**PLANNED UNIT DEVELOPMENT
& SUBDIVISION STAFF REPORT****August 7, 2017****DEVELOPMENT NAME** DJHB Subdivision**SUBDIVISION NAME** DJHB Subdivision**LOCATION** 601 Cody Road North
Southwest corner Cody Road North and Sellers Lane**CITY COUNCIL
DISTRICT** District 7**AREA OF PROPERTY** 1 Lot / 0.5 ± acres**CONTEMPLATED USE** Planned Unit Development Approval to allow multiple buildings on a single building site, and to create a legal lot of record from a metes-and-bounds parcel.**TIME SCHEDULE
FOR DEVELOPMENT** September 1, 2017**ENGINEERING
COMMENTS**

SITE PLAN

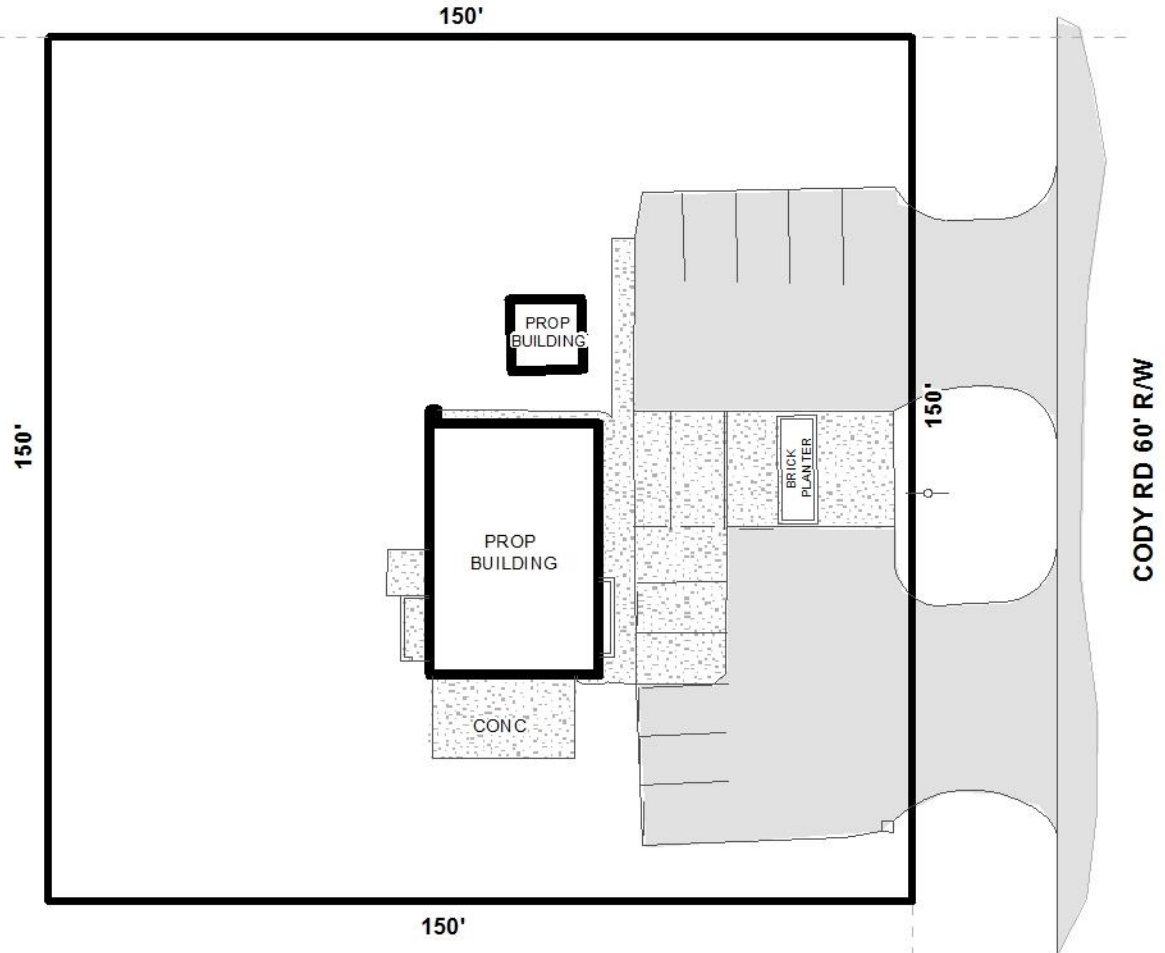
The preliminary plat nor the site plan depict the lot size in square feet and acres. The plat and site plan should both be revised to depict lot size in square feet and acres, if approved.

The site fronts Cody Road North, a proposed major street with a required right-of-way width of 100', as shown on the Major Street Plan. However, the plat depicts the right-of-way width of Cody Road North as 60 feet. Therefore dedication to provide 50' from centerline of Cody Road North will be required. The site also fronts Sellers Lane, a minor street with curb and gutter with an adequate 50' right-of-way provided.

The 25-foot minimum building setback line is not depicted on the preliminary plat or on the site plan. Both the plat and the site plan should be revised to depict the 25' minimum building setback line to reflect dedication where it applies.

The site currently has 2 existing curb-cuts to Cody Road North. As the site is currently developed and no plans for redevelopment, the site should be limited to the existing curb-cuts with any changes to the size, location and design to be approved by Traffic Engineering and conform to AASHTO standards.

Lastly, it should be pointed out that the site plan depicts the property boundaries as being 150.00' in width and length; however the actual property lines on the site plan do not measure to a standard engineering scale. Please verify property lines and boundaries and revise the site plan and preliminary plat to reflect accurate to scale measurements/ dimensions.

- 1) *revision of the site plan to depict the lot size in square feet and acres;*
- 2) *dedication sufficient to provide 50’ from centerline of Cody Road North;*

- 3) *revision of the 25’ minimum building setback lines to reflect dedication where it applies;*
- 4) *revision of the plat to ensure property line boundaries match the labelled dimensions and measure to scale;*

- 5) *placement of a note on the site plan stating that the lot is limited to the existing curb-cuts, with any changes to the size, design and location to be approved by Traffic Engineering and comply with AASHTO standards;*
